ADDENDUM NO. 1

CITY OF ROLLA
TAXIWAY A RECONSTRUCTION AND TAXIWAY CONNECTOR REHABILITATION
at
ROLLA NATIONAL AIRPORT (VIH)
VICHY, MO

MoDOT Project # 23-056A-1

ADDENDUM NO. 1

UNDERDRAIN PLAN
TAXIWAY A (STA. 05+00 - 10+00)

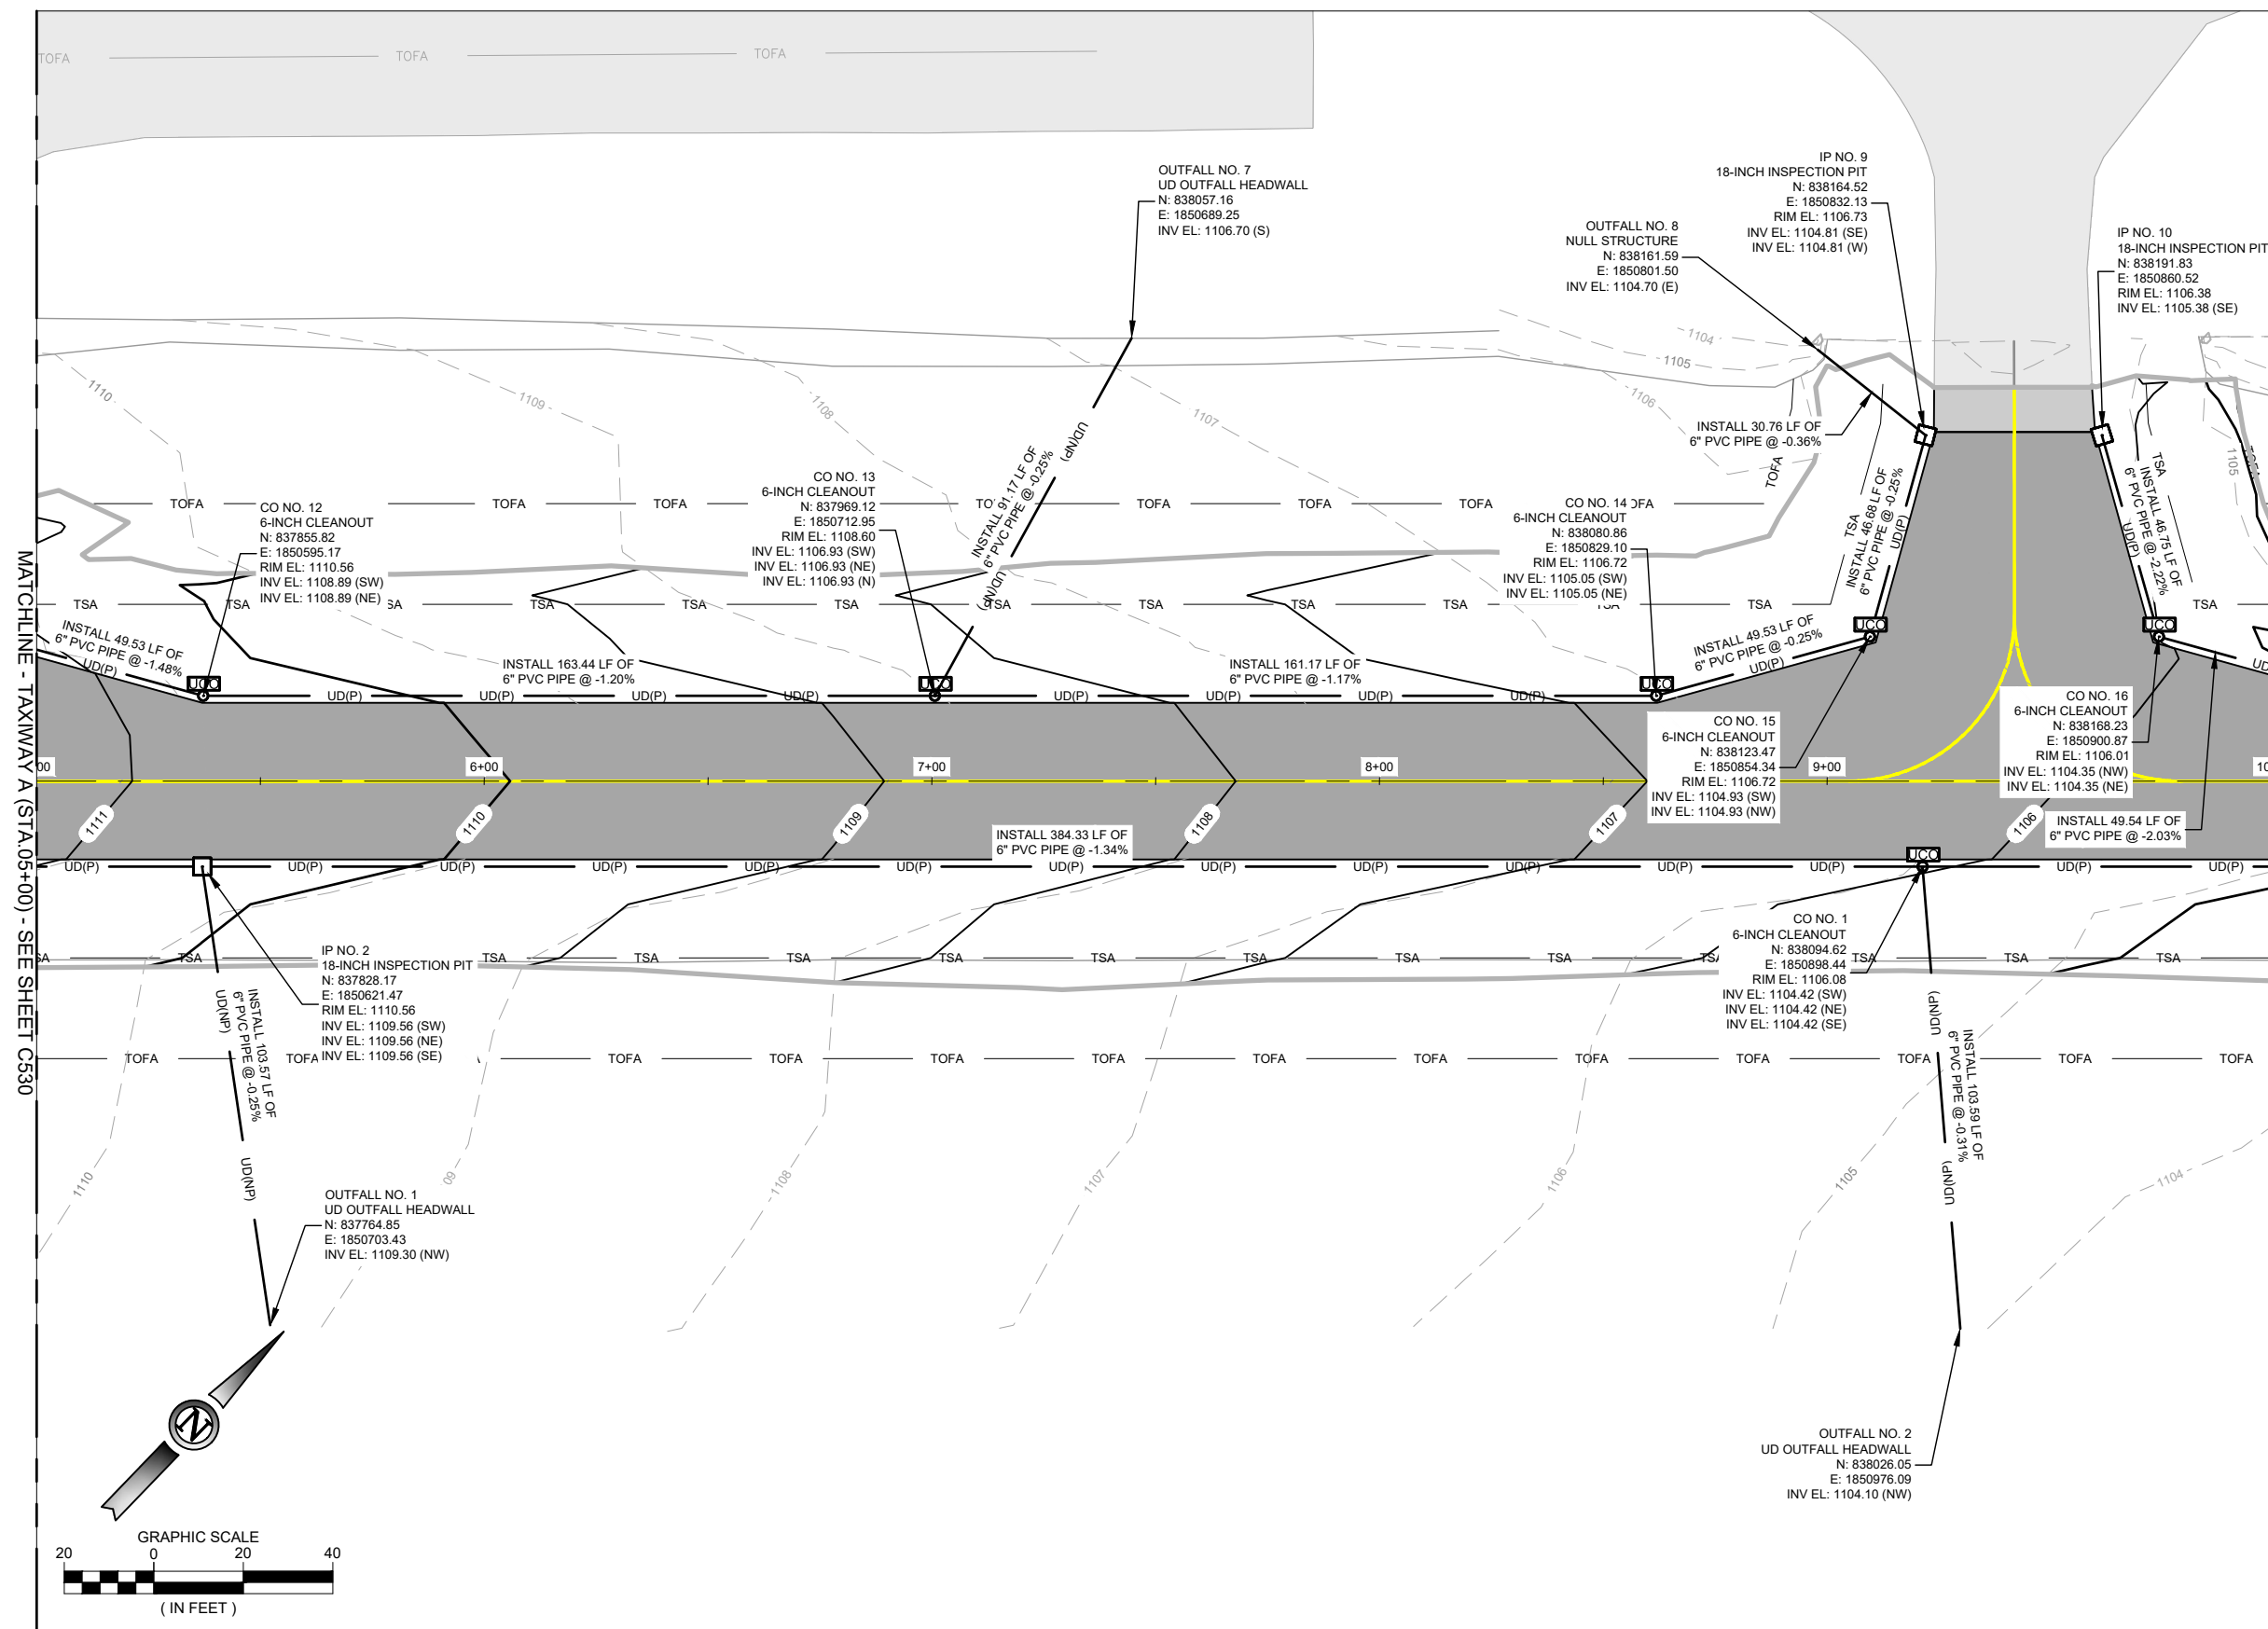
Revision: Added matchline at STA. 05+00 and updated sheet number for matchline at STA. 10+00.

Justification: The matchline was incorrect on either side of the sheet.

Justification: The invert elevations were raised to better meet the existing conditions. A new outfall was added to previous IP NO. 6.

UNDERDRAIN PLAN
TAXIWAY A (STA. 10+00 - 15+00)

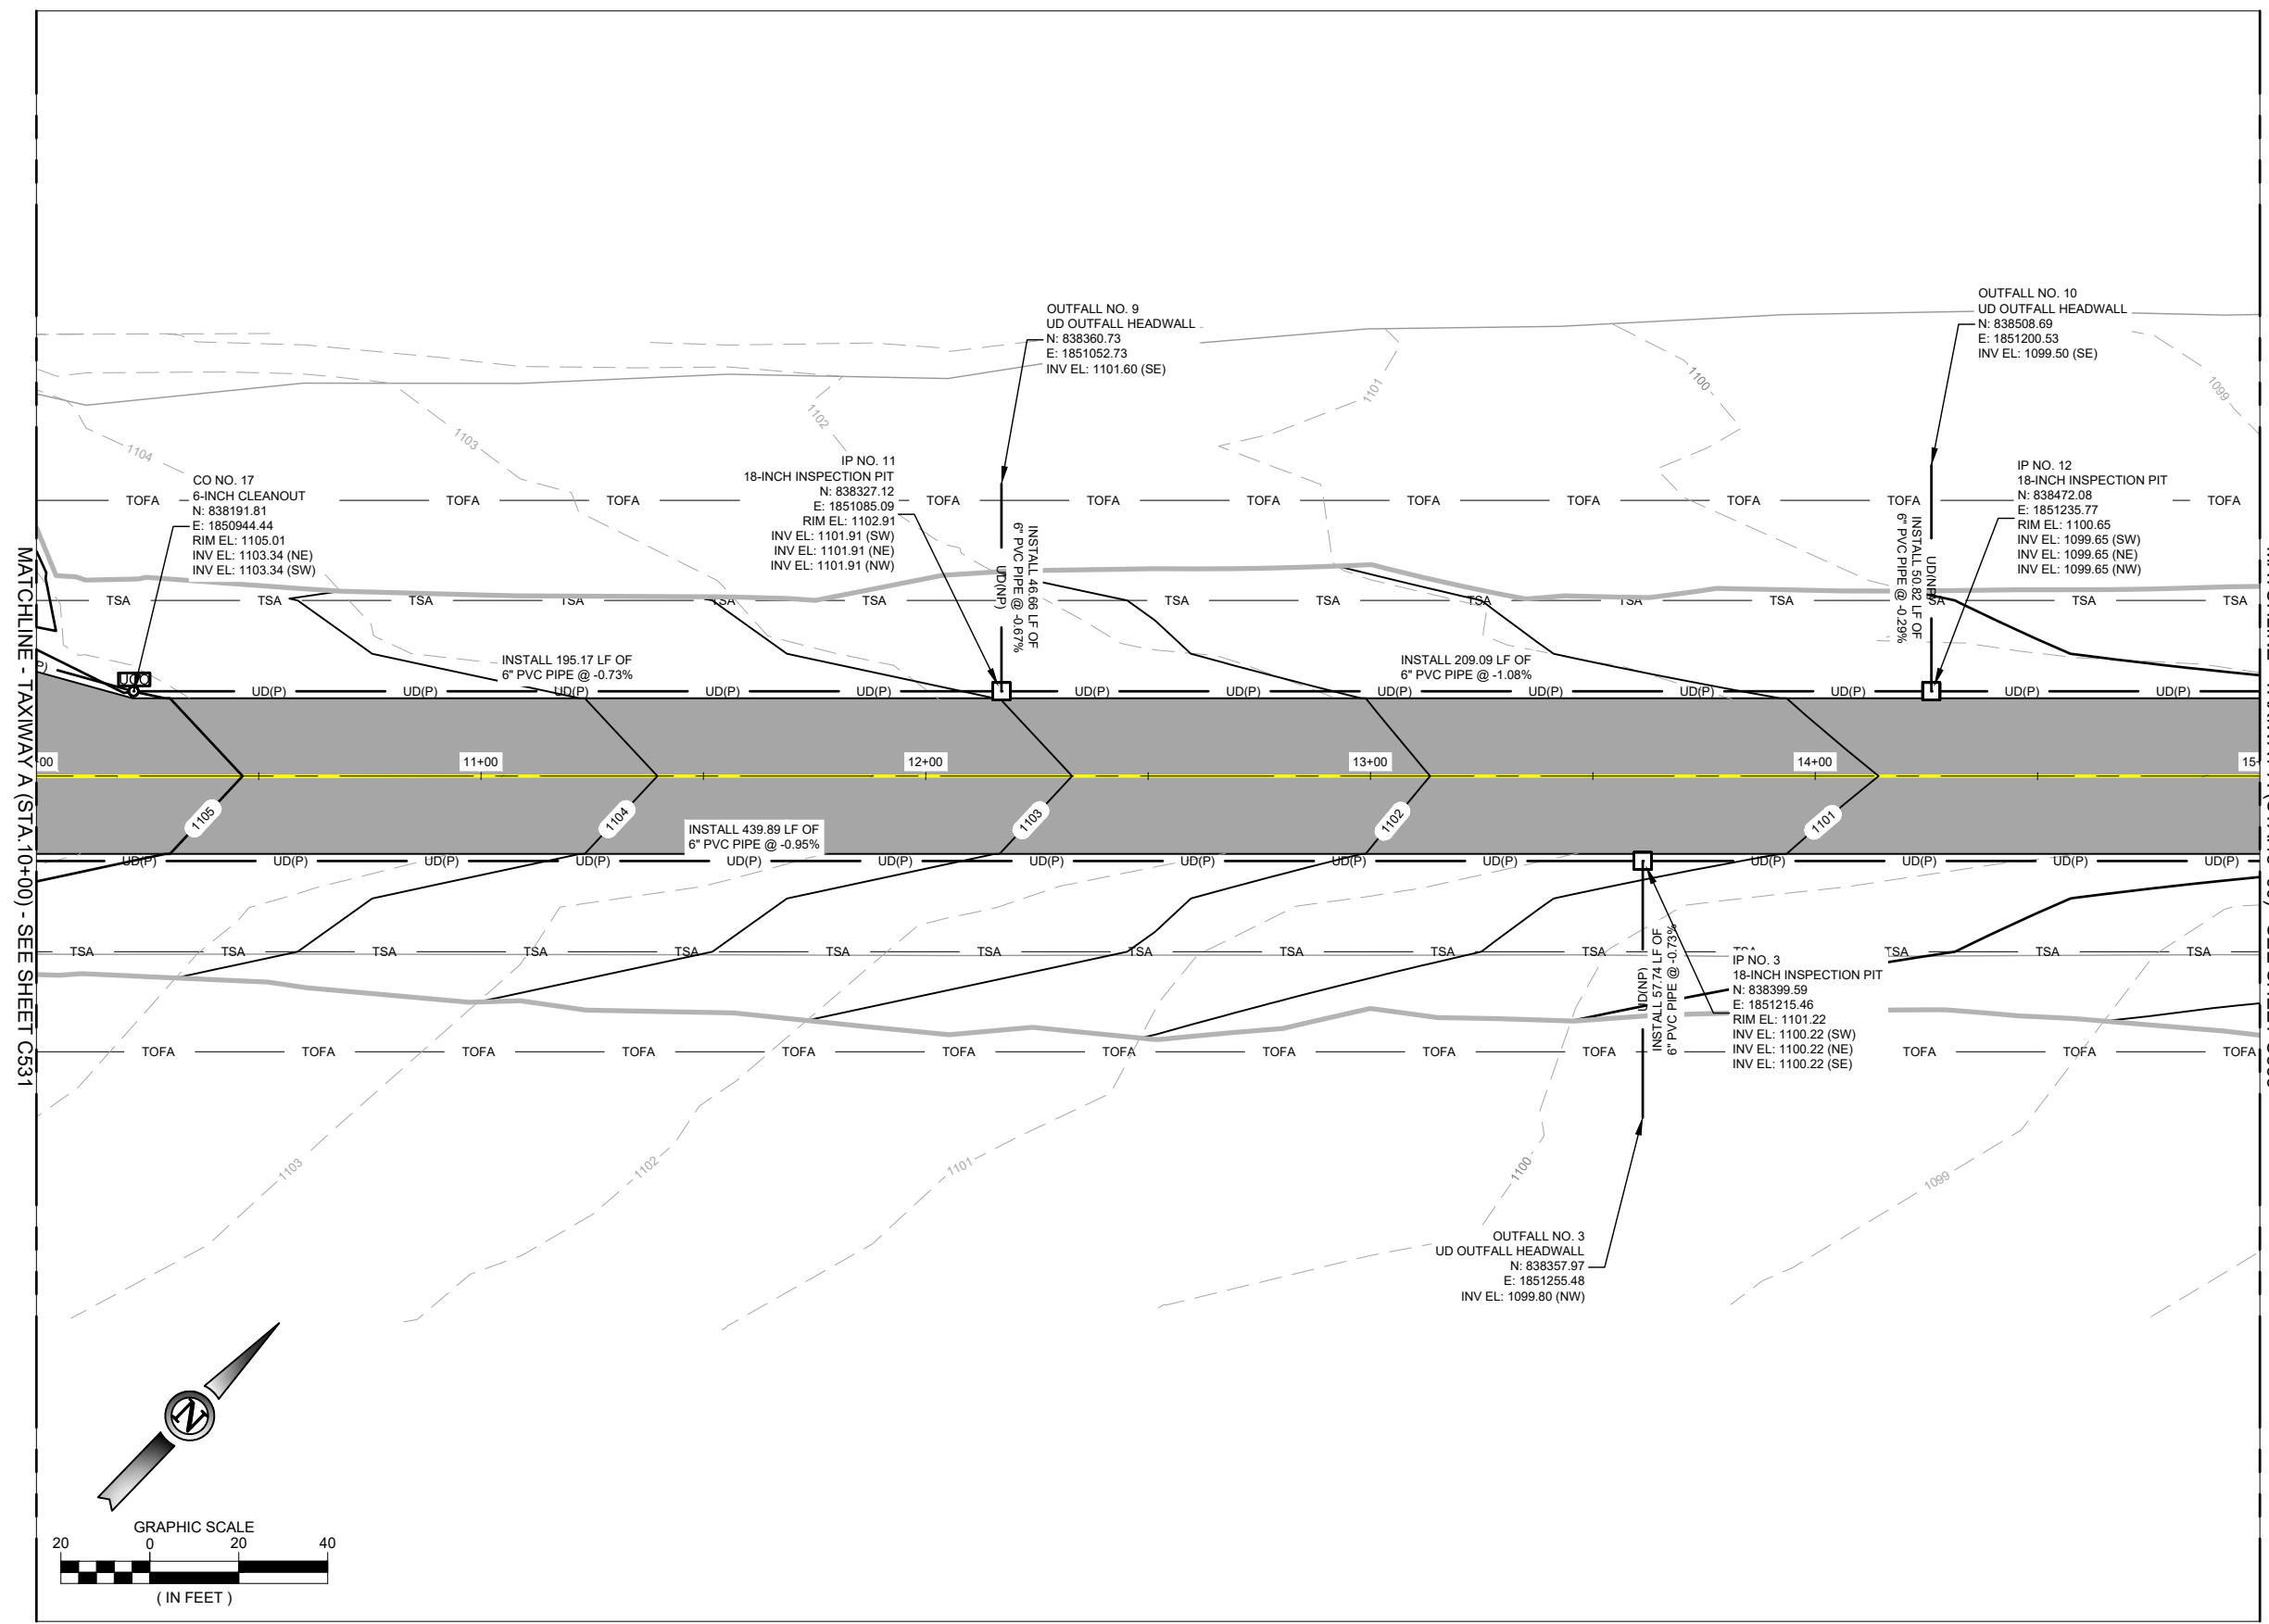
Revision: Added matchline at STA. 10+00 and updated sheet number for matchline at STA. 15+00.

Justification: The matchline was incorrect on either side of the sheet.

SHEET NAME C533
SHEET NO. 40 of 54

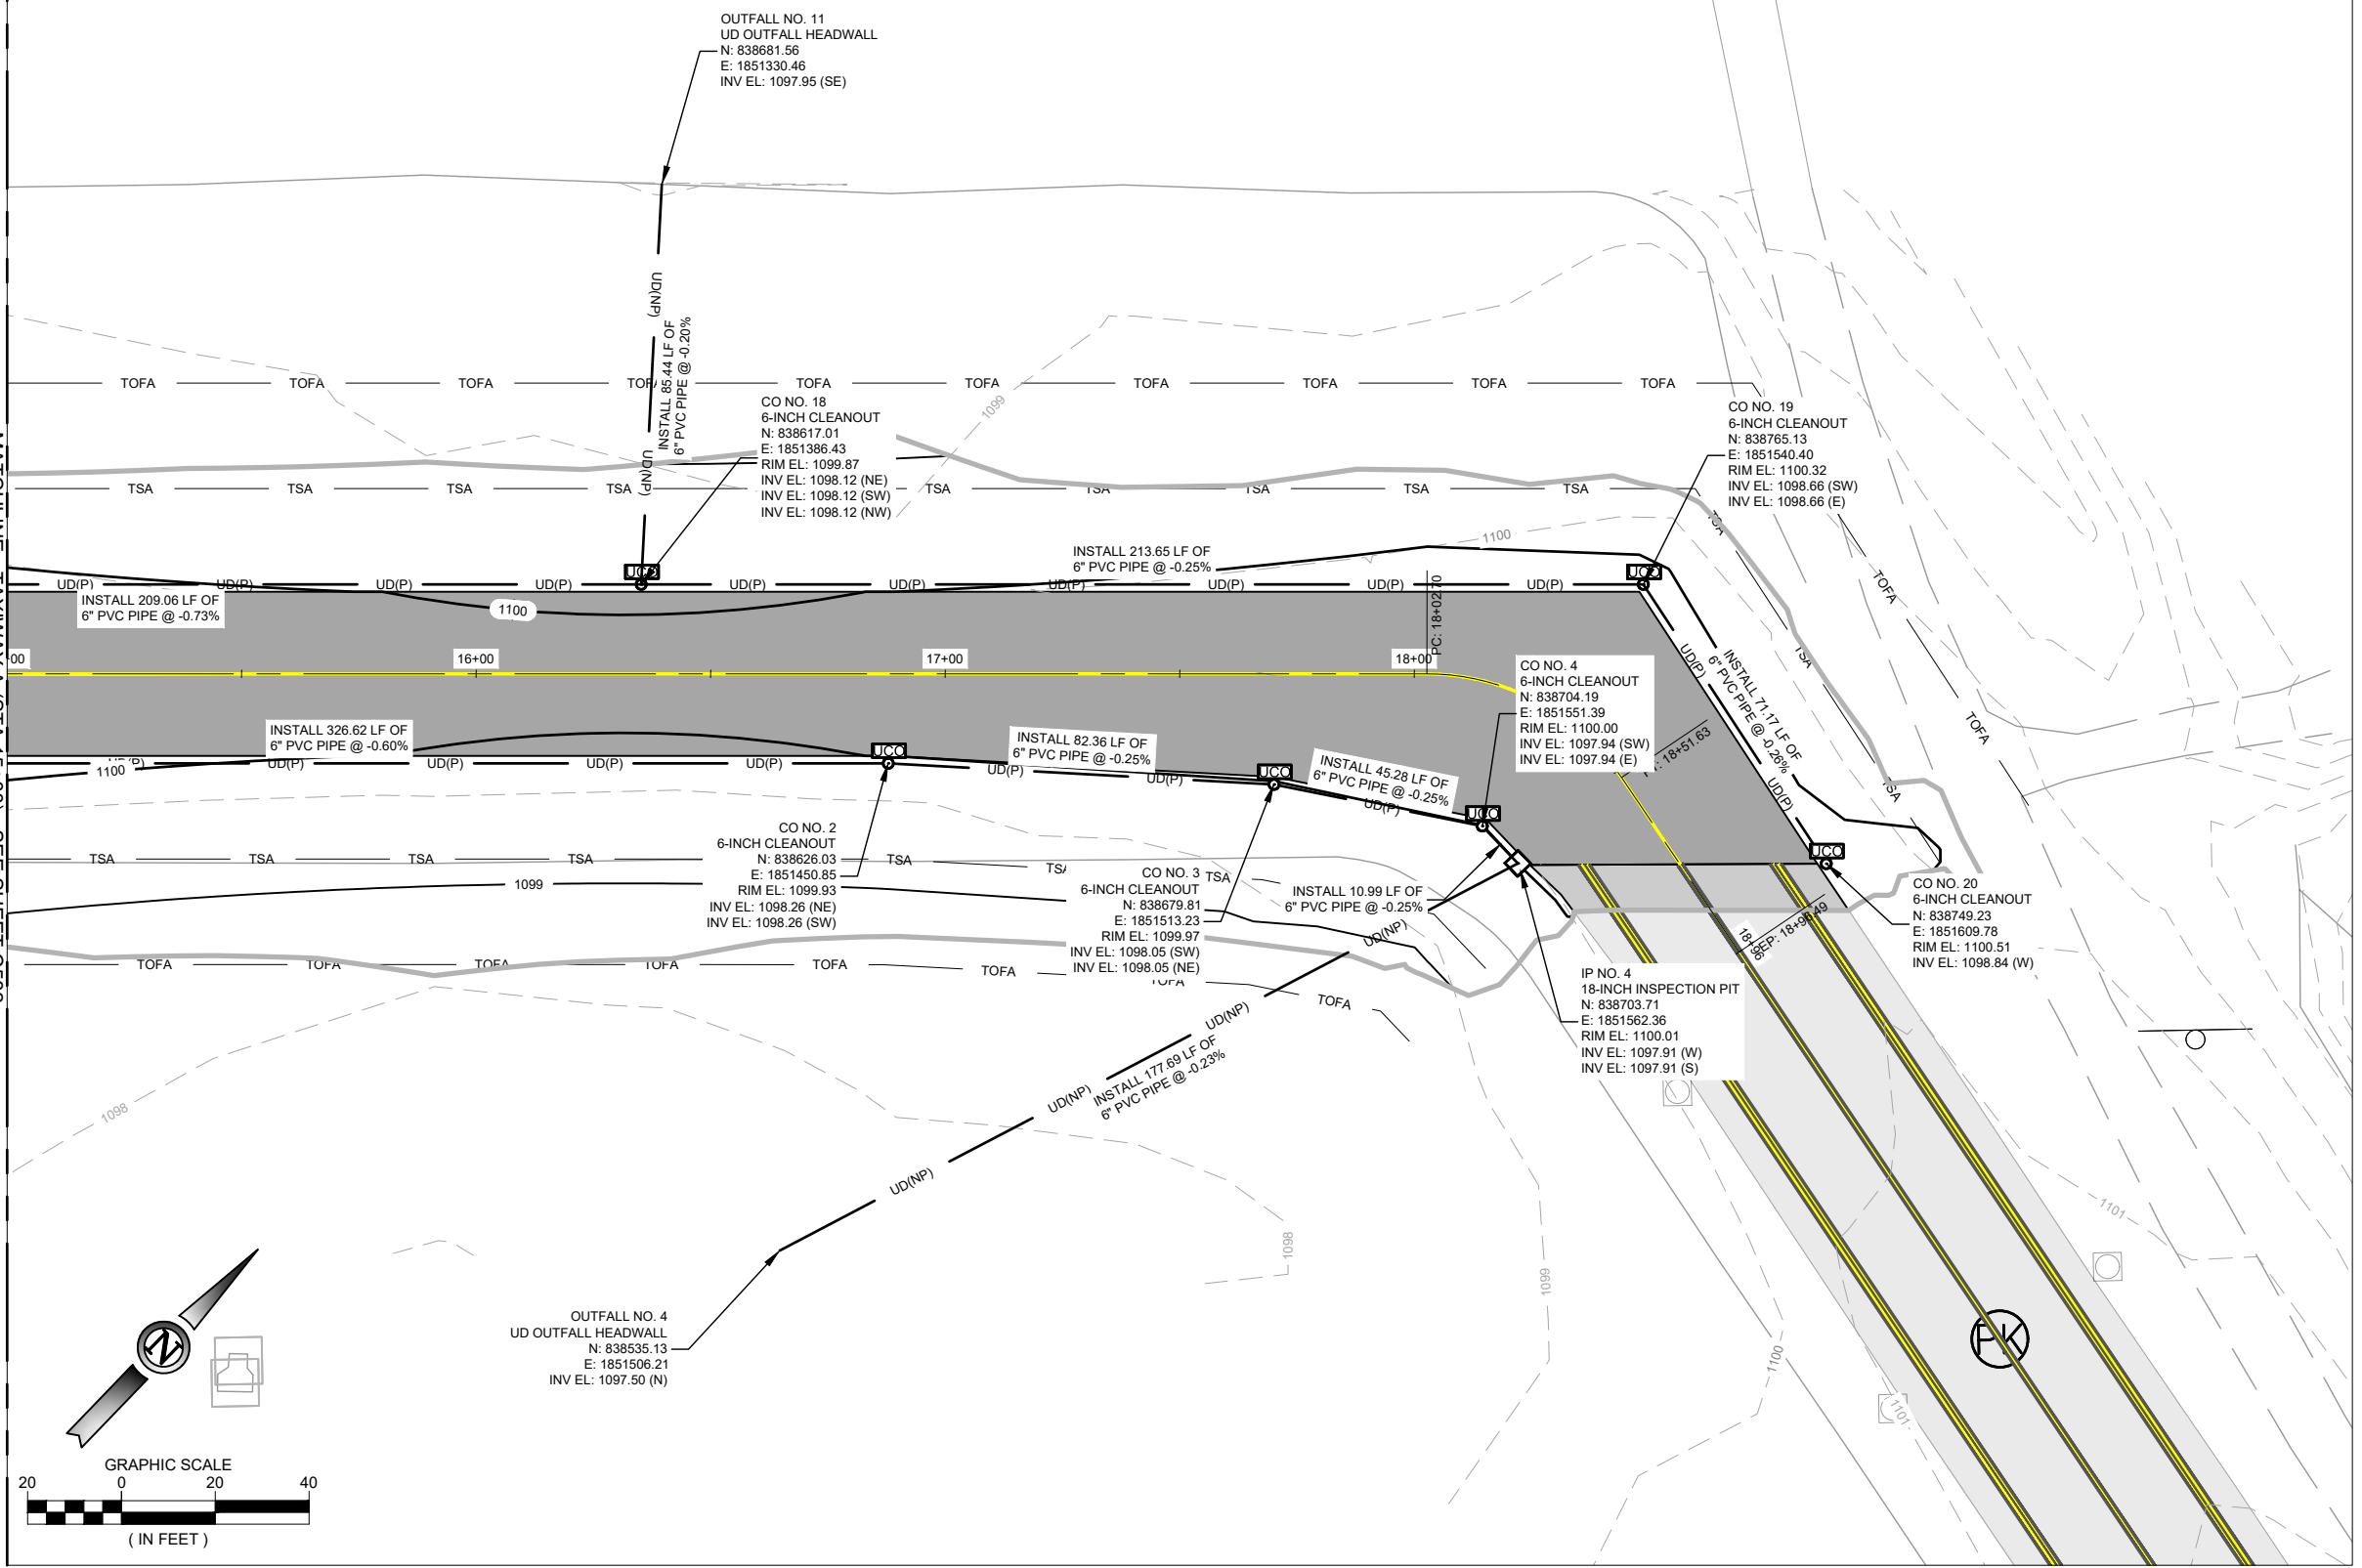
Revision: Added matchline at STA. 15+00 and removed matchline at STA. 19+00.

Justification: The matchline was incorrect on either side of the sheet.
